Comments submitted by: Alyssa Millard

Name(s)	Statewide Abatement of Impaired Land (SAIL) and Water Sections
Agency/Organization	Alaska Department of Natural Resources-Division of Mining, Land and Water
Document Reviewed	Draft Land Use Controls Implementation Plan Version Dated November 2022 Moose Creek, Alaska

Additional information for comment #3

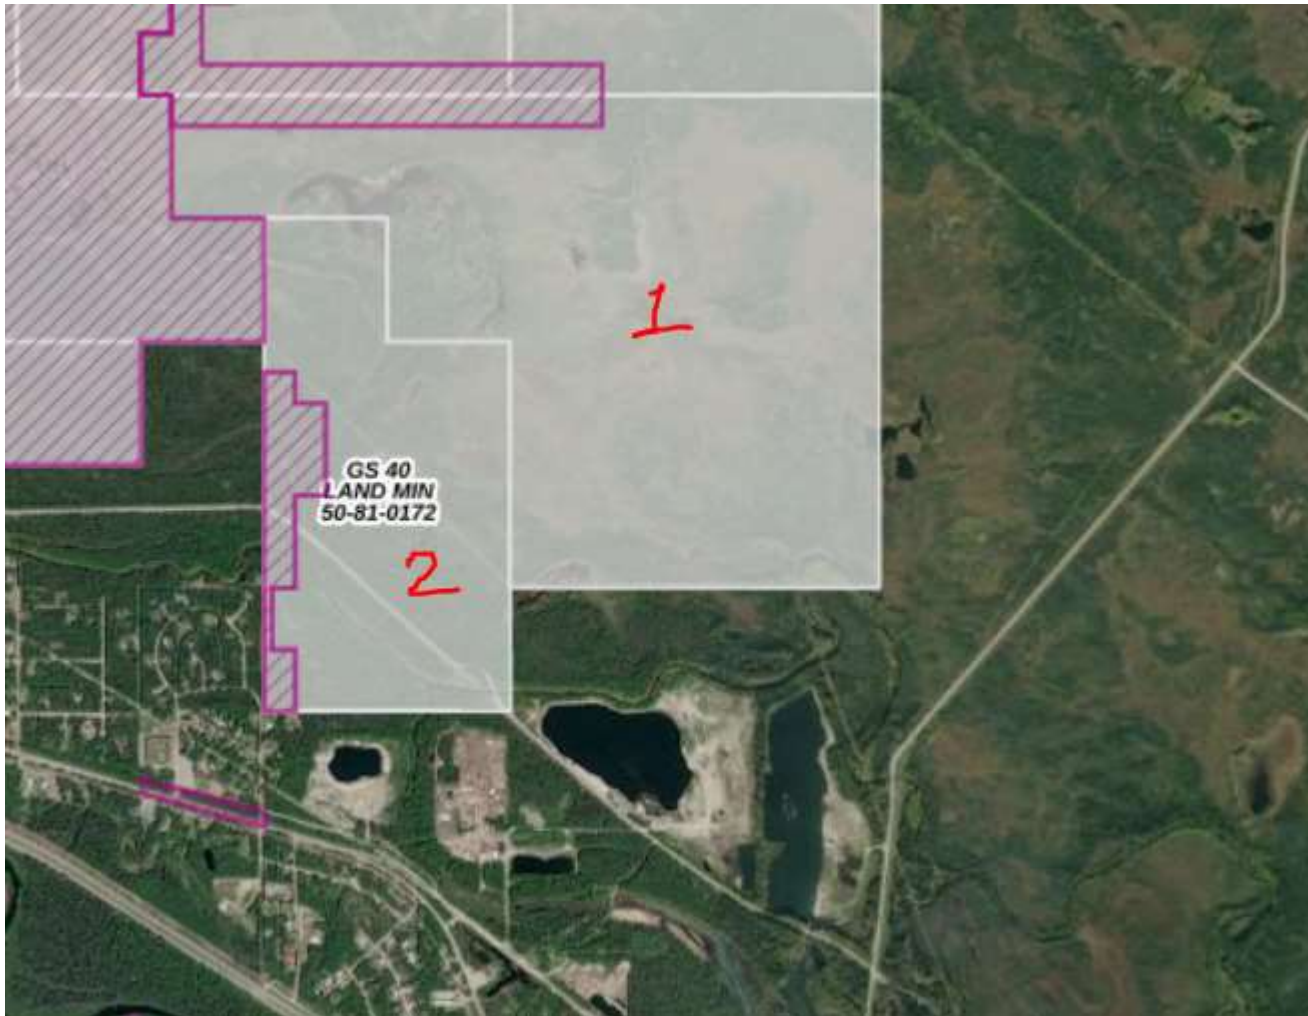
3.	ADNR	SAIL	2.2	4	Please work with DNR-SAIL to determine the best way to assign covenants to the state parcels. For example, should we use the smallest tax parcel or attached the covenant to the patent. Suggest changing the follow sentence until discussions occur: “The ADNR is the owner of seven individual parcels within Moose Creek.” Additionally, why is parcel (PAN 701036) south of the CWMA boundary included in	Concur. Text has been revised as recommended. Parcel 701036 will not be included in the LUC plan. Response: First comment not addressed. See additional notes below the table. Appendix A: Property Listing Table lists 7 parcels but figure 3 shows 6 parcels.

Two Parcel options based on the patent:

Red label #1 GS 40 Patent 1232752

Red label #2 GS 40 Patent 50-81-0172

State parcels are in grey, pink/purple are lands that have been conveyed out of state ownership.

No.	Agency	Office	Document Section	Page No.	Wording Change/Comment	
					<p>this LUC plan? Has contamination been documented on this parcel? Referencing Appendix A, I don't see this parcel listed.</p> <p>If it should not be included remove it from the Figure 3 map.</p>	<p>09/20/2023 AF Response: How DNR wishes to assign covenants to the state parcels, will be up to DNR. AF is available to consult with as DNR is working through the process.</p> <p>Table list will be corrected to only show the 6 parcels as highlighted on the figure.</p> <p>10/10/2023 DNR agree</p>
